**Flood Control Project Maintenance
Levee Inspections**

Maintenance Issue Types Only, Levee Inspection Report By Mile - Fall 2014

Reclamation District No. 0765 Glide

Waterway	Bank	Unit Miles	Inspection Start/End	Inspector
Unit No. 01 Sacramento River	Right	1.72	10/27/2014 10/27/2014	Richard Willoughby

Photo 1 of 5 : FA_2014_RD0765_211_81_20141020_00069.jpg

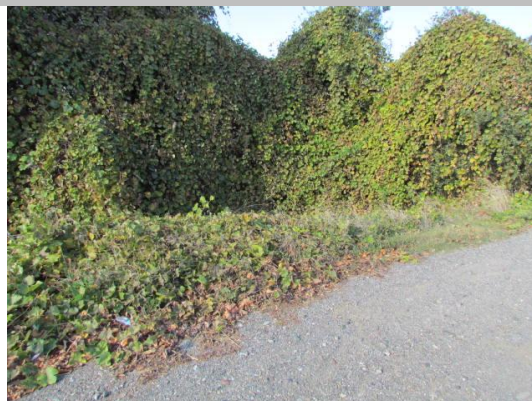
LM Start	0.97	Rating **	M	Issue No.	81
LM End	0.97	Issue Type +	Ma	Location *	LS
Category	Earthen Levee			GPS Latitude/Longitude	
				Start	End
Item	Vegetation			38.489962 °	38.489962 °
				-121.555573 °	-121.555573 °
DWR ID	DWR_RD0765_01_s_2012_81				
Action/Comments					
Remove the wild growth other than native grasses from the levee slopes.					
Inspector Comments: Dense berryvines on landside slope.

Looking west at dense berryvines and wildroses on landside shoulder and slope. (November 2011)

Photo 1 of 2 : FA_2014_RD0765_211_5_20141020_00005.jpg

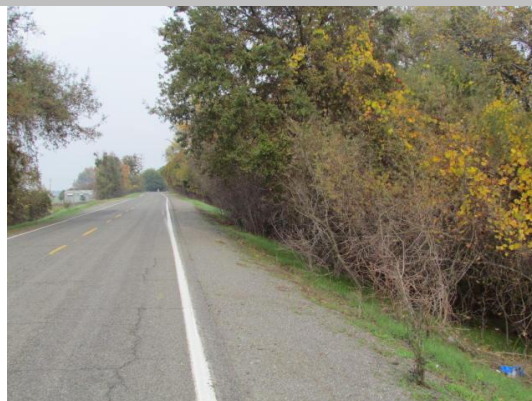
LM Start	1.44	Rating **	A/W	Issue No.	5
LM End	1.47	Issue Type +	Ma	Location *	WS
Category	Earthen Levee			GPS Latitude/Longitude	
				Start	End
Item	Trim / Thin Trees			38.483925 °	38.483530 °
				-121.551845 °	-121.551587 °
DWR ID	DWR_RD0765_01_s_2012_5				
Action/Comments					
Thin trees to allow visibility of the ground and room to flood fight.

Looking north at dense vegetation on waterside slope. (Fall Inspection 2012)
